Public Comment No. 979-NFPA 70-2018 [Global Input]

This Global Public Comment requests that each CMP review all products under their purview and determine whether reconditioning should be permitted. This public comment is submitted by a task group assigned by the NEC Correlating Committee. This task group was charged with reviewing Public Input 2935 which was resolved by CMP-1 during the first draft stage. This PI would have required that "Reconditioned Equipment" be "listed as "reconditioned" and the "original listing marks removed". This PI has ramifications that are global in nature and impacts all products referenced in the NEC under the purview of every CMP.

Figure 210.52(C)(1) Determination of Area Behind a Range, Counter-Mounted Cooking Unit, or Sink.

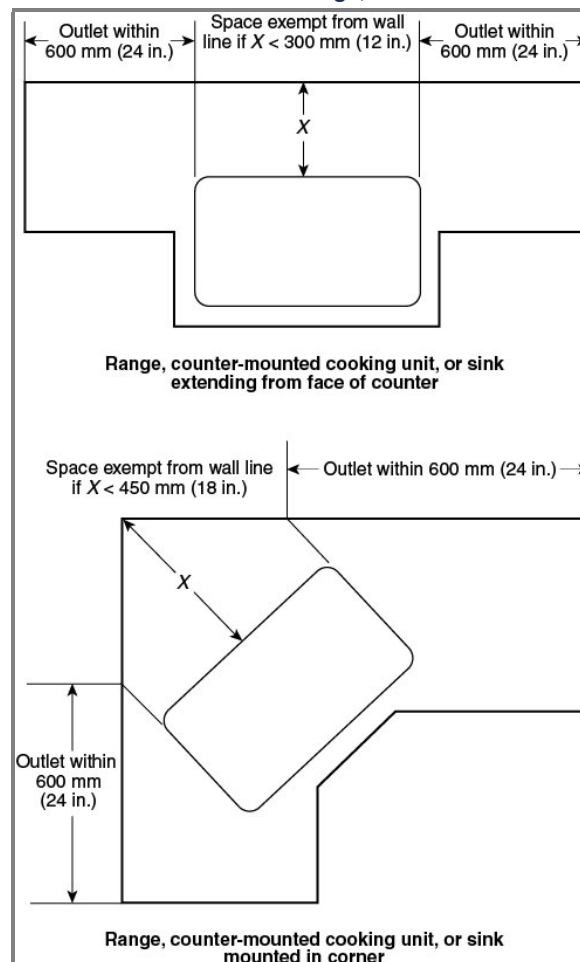
Exception: Receptacle outlets shall not be required directly behind a range, counter-mounted cooking unit, or sink in the installation described in Figure 210.52(C)(1).

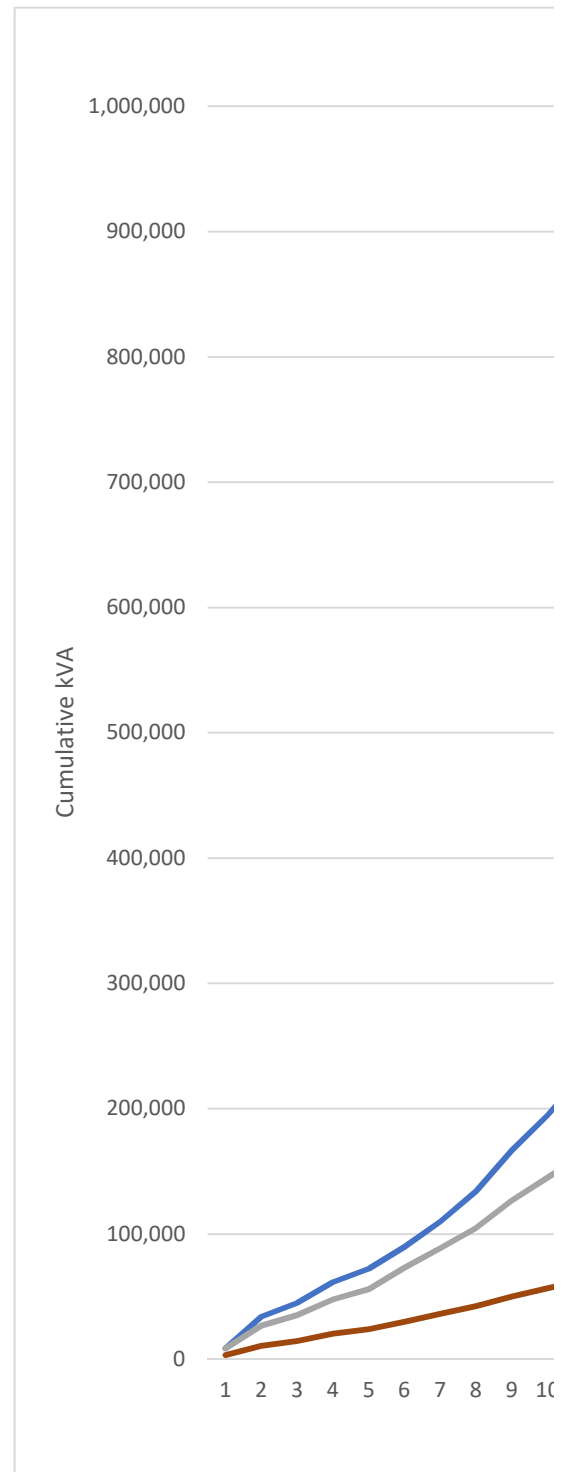
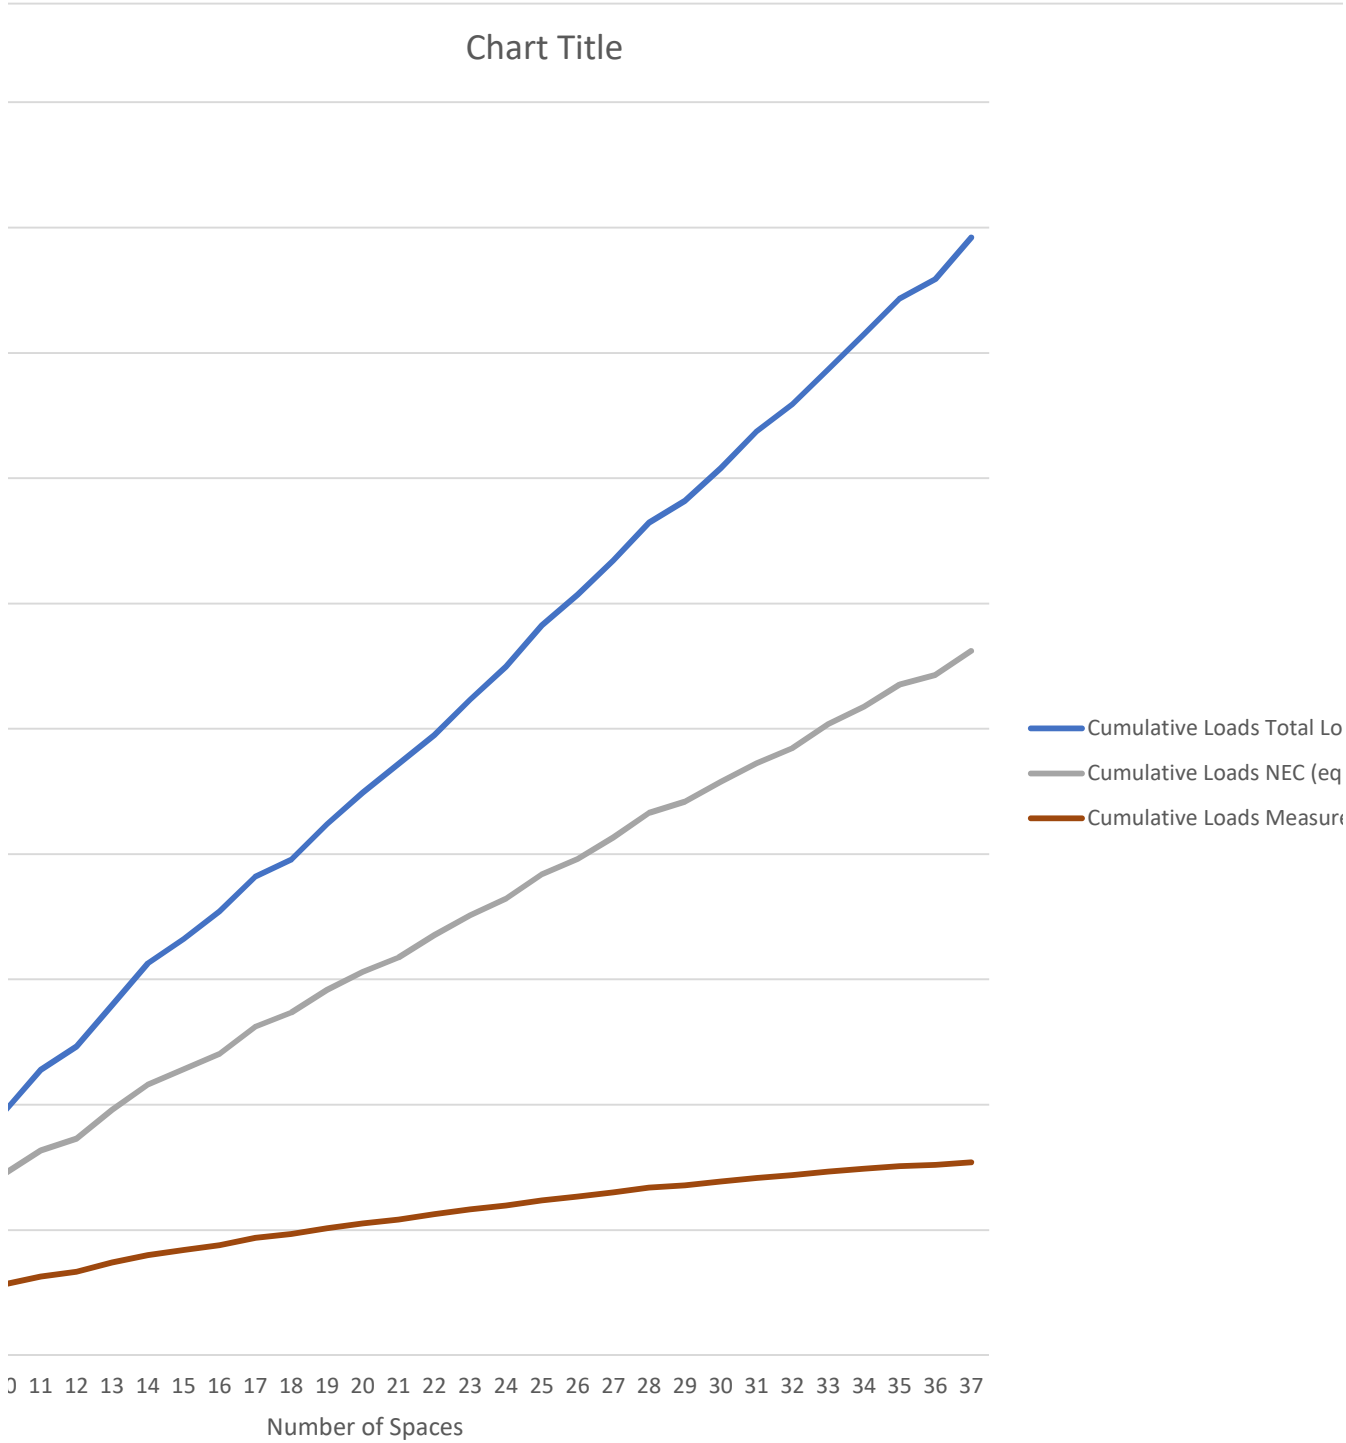
Row #	Connected Load (VA)					Measured Peak VA
	# Recepts	Recep load	# CORD CONN EQP	Cord Con Load (nameplate)	Total Conn. Load, equip at nameplate	
22	22	3,960	8	4,681	8,641	3,290
37	113	20,340	5	5,080	25,420	7,550
34	28	5,040	7	5,843	10,883	3,790
26	47	8,460	7	8,302	16,762	5,760
35	28	5,040	7	5,663	10,703	3,670
16	3	540	23	16,712	17,252	5,780
25	50	9,000	13	11,302	20,302	6,420
21	92	16,560	9	7,602	24,162	6,140
8	118	21,240	11	11,326	32,566	7,680
9	107	19,260	14	8,976	28,236	6,620
1	164	29,520	4	3,400	32,920	6,240
20	102	18,360	1	360	18,720	3,850
5	111	19,980	17	12,914	32,894	7,230
7	147	26,460	10	7,007	33,467	5,950
30	76	13,680	7	5,584	19,264	4,000
15	110	19,800	6	2,310	22,110	3,880
31	66	11,880	13	15,805	27,685	5,920
10	28	5,040	21	8,716	13,756	3,010
32	113	20,340	7	7,837	28,177	4,750
24	119	21,420	5	3,620	25,040	3,710
14	128	23,040	0	0	23,040	3,150
27	57	10,260	18	12,767	23,027	4,350
17	138	24,840	4	3,333	28,173	3,650

NEC DEMAND LOAD	Safety Factor Above Measured Demand	Cumulative Loads				
CORD CONN AT nameplate	NEC (w/ eqp at nameplate)	Measured peak demand	Recep Load	Cord Conn Load (nameplate)	Total Load (w/ eqp at nameplate)	NEC (w/ eqp at nameplate)
8,641	163%	3,290	3,960	4,681	8,641	8,641
20,250	168%	10,840	24,300	9,761	34,061	26,911
10,883	187%	14,630	29,340	15,604	44,944	35,274
16,762	191%	20,390	37,800	23,906	61,706	47,806
10,703	192%	24,060	42,840	29,569	72,409	55,989
17,252	198%	29,840	43,380	46,281	89,661	72,971
20,302	216%	36,260	52,380	57,583	109,963	88,773
20,882	240%	42,400	68,940	65,185	134,125	104,655
26,946	251%	50,080	90,180	76,511	166,691	126,601
23,606	257%	56,700	109,440	85,487	194,927	145,207
23,160	271%	62,940	138,960	88,887	227,847	163,367
14,540	278%	66,790	157,320	89,247	246,567	172,907
27,904	286%	74,020	177,300	102,161	279,461	195,811
25,237	324%	79,970	203,760	109,168	312,928	216,048
17,424	336%	83,970	217,440	114,752	332,192	228,472
